PR/0105/23

Record of Executive Business and Chief Executive's Order

Reg. Reference: SD22A/0081 **Application Date:** 21-Mar-2022
Submission Type: Clarification of Additional Information **Registration Date:** 23-Dec-2022

Proposed Development: Relocation of the existing Clondalkin RFC grounds at Gordon Park to new lands at Kingswood Farm, Moneenalion Commons Lower Clondalkin and comprising of 4 new rugby playing pitches, including a high quality main competition pitch (with modern directional floodlighting comprising 18m high floodlighting columns either side) and a high quality Junior pitch both laid approximately level, and two back pitches as well as various grassed rugby training areas all laid on existing land cross fall levels; change of use of existing agricultural shed to accommodate new two storey changing facility and storage areas; a new two storey Clubhouse Pavilion with supporting facilities including dressing rooms, physio rooms, coffee dock, committee rooms, members bar and lounge, plantroom and toilets; all associated site development sustainability and infrastructure work including connection to existing public foul sewer, SUDs, sedum roof and PV roof panels; new

Fig.8: 'Members Bar' First Floor Area Calculation

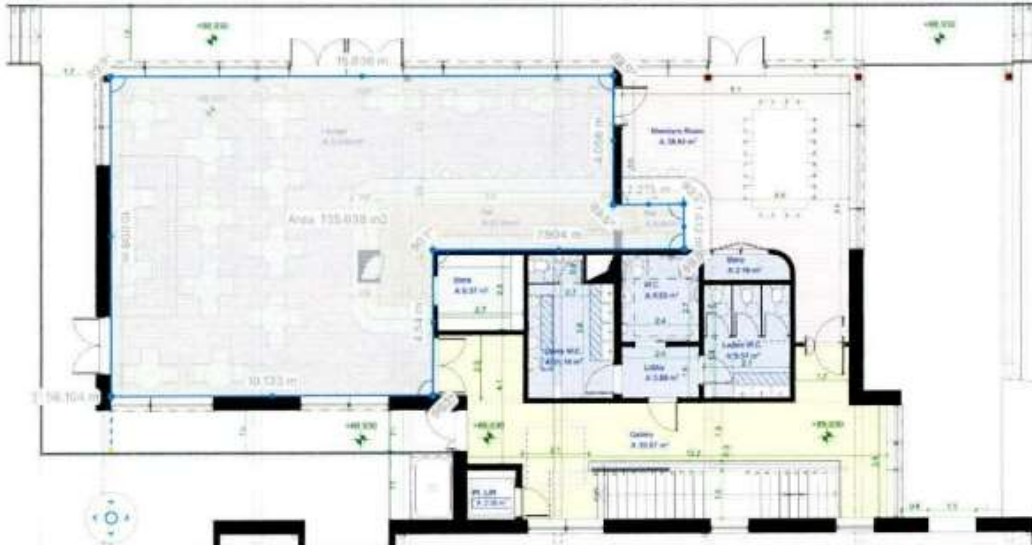
(a) The application includes the provision of a Member s Bar. For 'RU' zoning a public house which is defined as 'A building or part thereof or land licensed for the sale of intoxicating liquor to the public for consumption on the premises', is Open For Consideration but only in Villages to serve local needs. The proposal does not include a justification for the Members Bar in the information submitted to the Planning Authority. Therefore, the applicant is requested to submit information demonstrating a clear justification for the Member Bar.

portion of the Changing Rooms Building and Clubhouse Pavilion together. So, it is of a relatively small scale which is as it such be being ancillary to the proposed overall Sports and Recreational Facility use.

A Rugby Club is not just about the physical activity of playing rugby and being physically active, it is much more than that. It is a team sport, involving mens, womens and juvenile teams covering all age groups and as such building bonds between players and the wider club membership is very important. This is especially true as there are many Members, such as older retirees, ex-playing members, retired referees, Member's spouses and parents of the juveniles, etc who make valuable contributions to the Club and frankly these is no better way for the wider membership to get to know each other than in the convivial atmosphere of the clubhouse after a hard victory or loss. Indeed, its arguably that the real success of Clondalkin RFC over the last almost half-century has been the social bonding of a wide range of Members who have met and become friends over the years. People from the local environs of Clondalkin, Tallaght, Newcastle, Rathcoole and Saggart and further afield, as well as from all backgrounds and age groups.

Fig. 4.1 PROPOSED CYCLE TRACK ACCESS OFF R136:

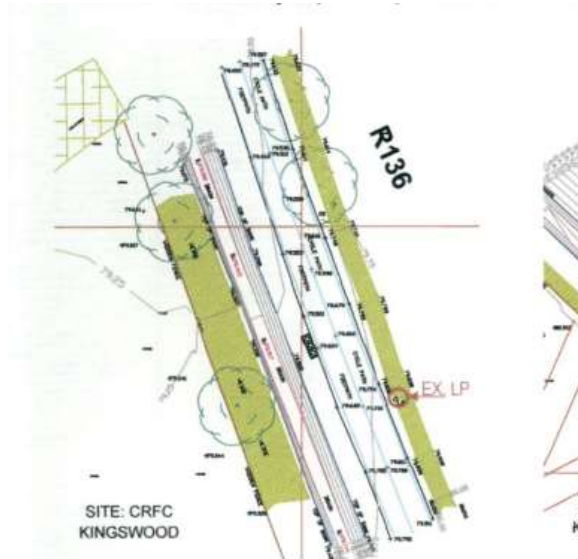
- 2. Applicant to submit further detail re proposed cycle track/entrance:*
 - a. Public lighting to be provided along any darkened sections of path.*
 - b. Confirmation in writing that permission has been granted from SDCC Development Department to create an entrance using council land.*

The intent was to take advantage of the existing public lighting infrastructure for both new entrances off the R136 and thereby avoid any impact on the existing Public Lighting services here while, at the same time, avoiding any unnecessary additional costs for all concerned in the pursuit of good sustainable development.

All lighting works on site will be carried out in accordance with the SDCC's Public Lighting Specification and Standard Details where applicable.

Fig. 4.2 PROPOSED PEDESTRAIN STAIRS ACCESS OFF R136:

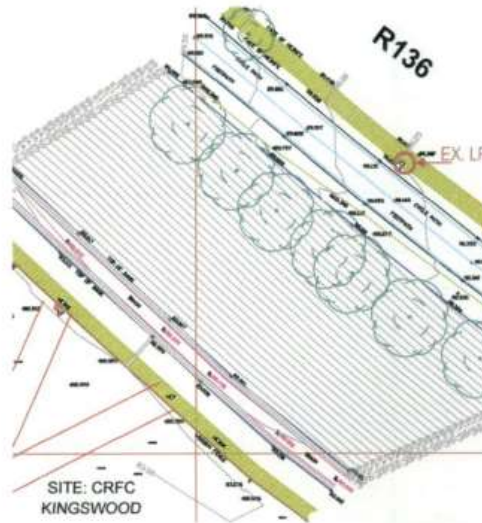
1. Applicant to submit a details/drawing of proposed stairs specification (materials, finishes, hand railings, lighting, gate, gradients, etc).
 - a. Plan drawing, section drawing and structural drawings (including rebar schedules where applicable).

The Pedestrian Access Stairs, on the other hand, must overcome a more significant level difference which is indeed just over 7m vertically. The stairs are also detailed in the bound A3 design set, specifically on Drawing Nos. A.03.05.1.3 and A.03.05.1.4 where it is shown in Plan, Sections and Perspective Views. Details of finishes, hand railings, landings, areas of tactile pavement etc are included.

To achieve a safe pitch for the Pedestrian Access Stairs, the R136 embankment earthworks will need to be extended out slightly, and locally, in order to provide proper direct support on new compacted fill material for the proposed new reinforced concrete stair. This embankment extension will be done using stepped benches in strict accordance with Transport Infrastructure Ireland's (TII) Standard Construction Details ref. CC-SCD-00608 and a copy of this drawing is included in Appendix B for ease of reference. There will be a number of level landings between flights, including top and mid-level rest area landings. The stair flight structure will include a formed RC key at the base of each RC flight, to effectively fix them them in place.

The Stairs and its landings will be fitted with stainless-steel guardrails and its handrail will include discrete integrated lights along its path. The Cycle Track access will have a timber handrail and standard bollard lighting at discrete positions along its entire Cycle Track route. Refer to the overall site Layout Drawing No. A.03.05.1.1 as well as Wink Lighting Report and associated Drawing No. A.03.05.1.4.
